Atlantic Crossing

CLASS II MODIFICATION 2019 - 8.2.2019

CLASS II MODIFICATION SUPPLEMENT 10.25.2019

PLAZA SUPPLEMENTAL EXHIBITS

BLDG III FIRST & SECOND FLOOR PLANS

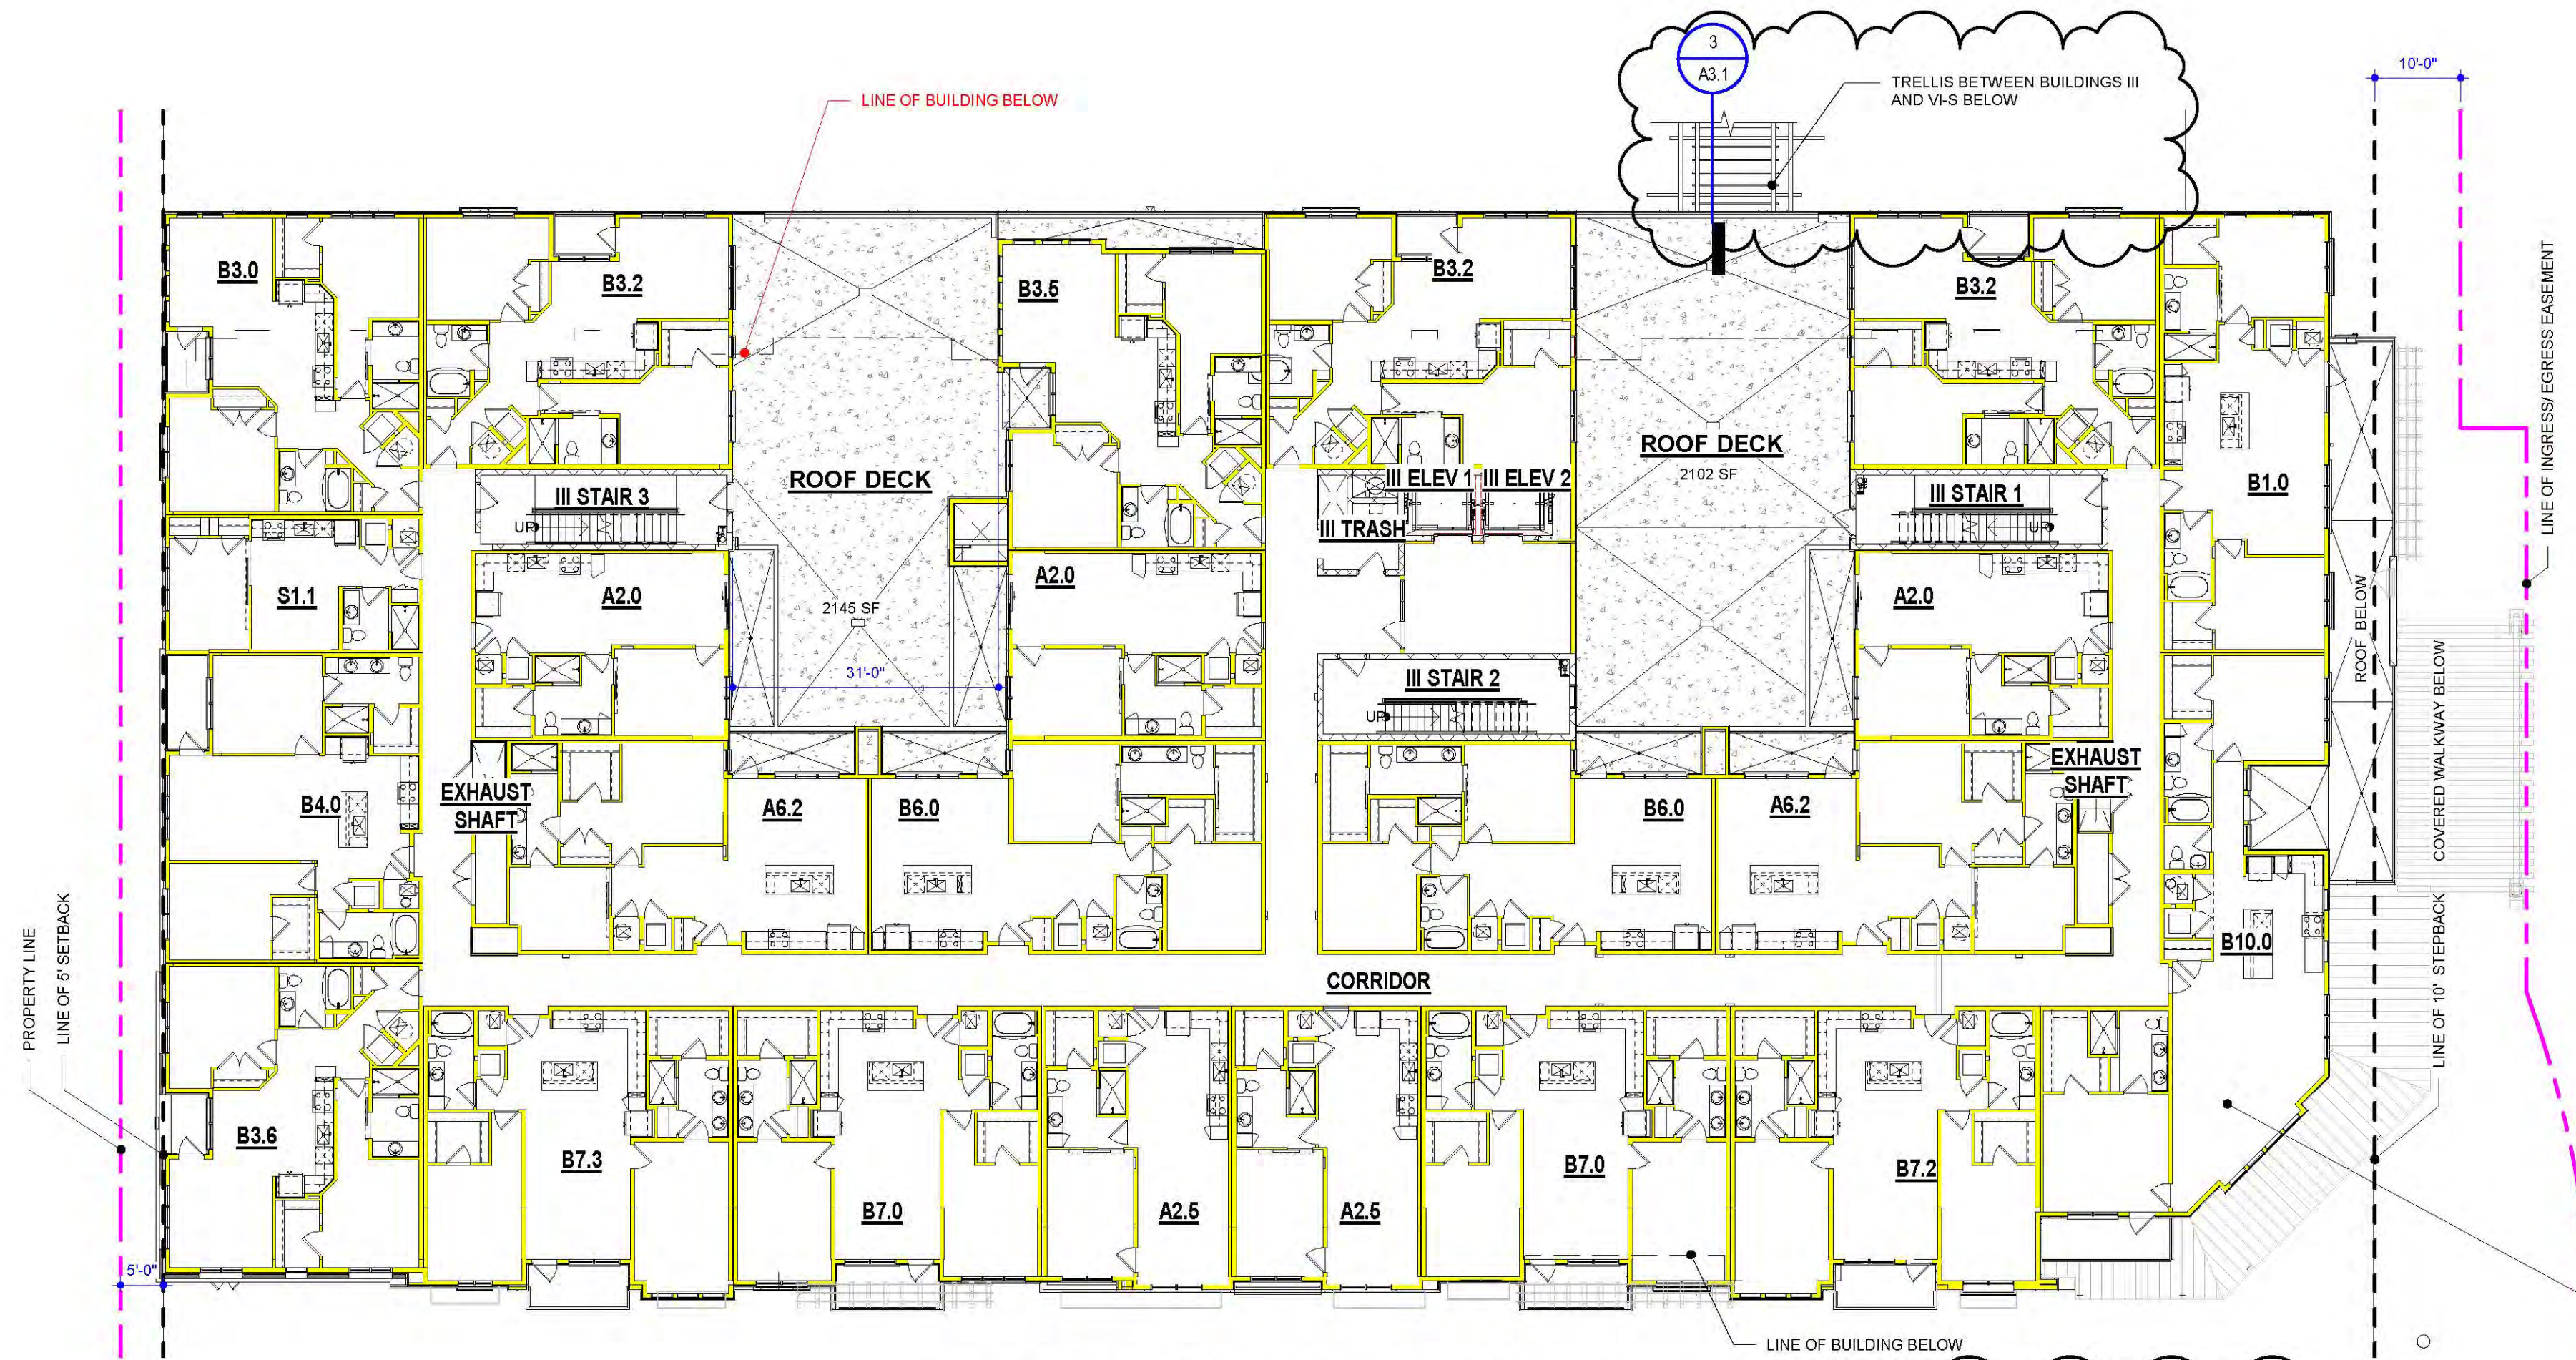
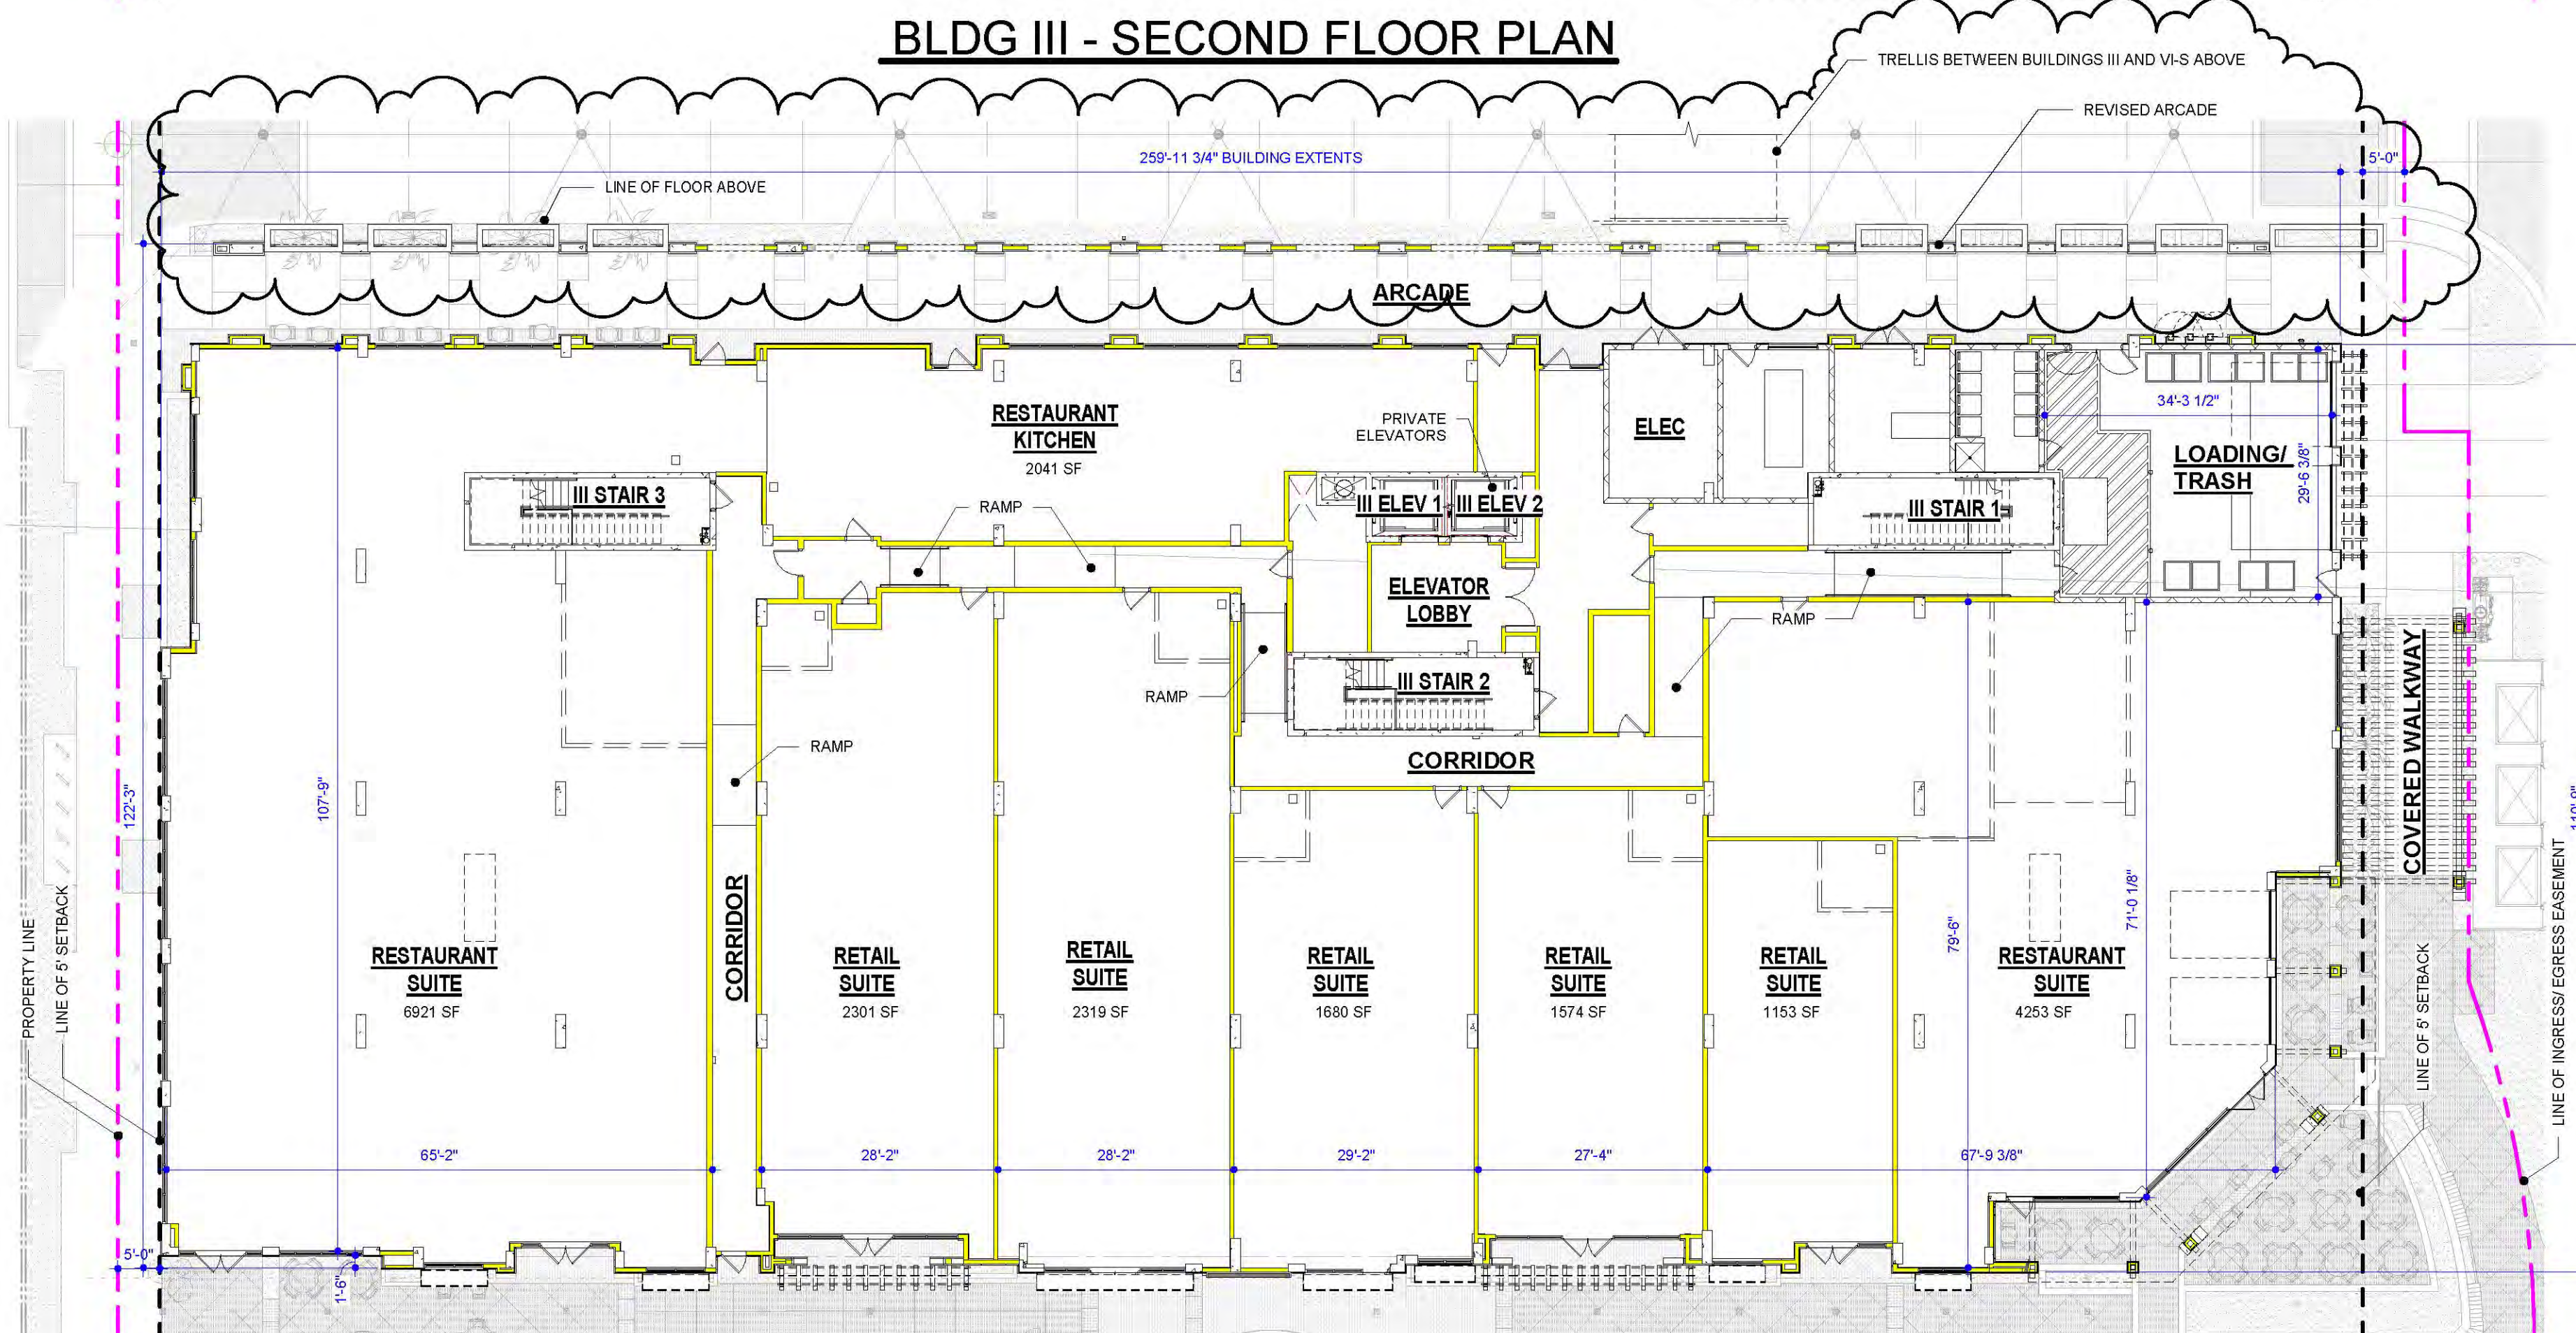
RESPONSE TO 2.12.14 STAFF COMMENTS

- BUILDING III NORTHWEST FOOTPRINT ADJUSTED DUE TO ADDITION OF RAMP AT NE 8TH AVENUE
- ADJUSTED EASEMENT LINE ON WEST SIDE OF N.E. 7TH AVE.
- FLOOR PLANS REFLECT RESIDENTIAL UNIT COUNTS.

RESPONSE TO 2.6.15 STAFF COMMENTS

- REFORMATTED UNIT MATRIX
- SETTLEMENT MODIFICATION 4.21.2017
- ADD ARCADE TO THE NORTH AND REDUCED SQUARE FOOTAGE ACCORDINGLY
- DELETED CANTILEVER ON NORTH AT SECOND FLOOR

- REVISE DETAIL AT ARCADE
- ADD TRELLIS BETWEEN III & VI-S
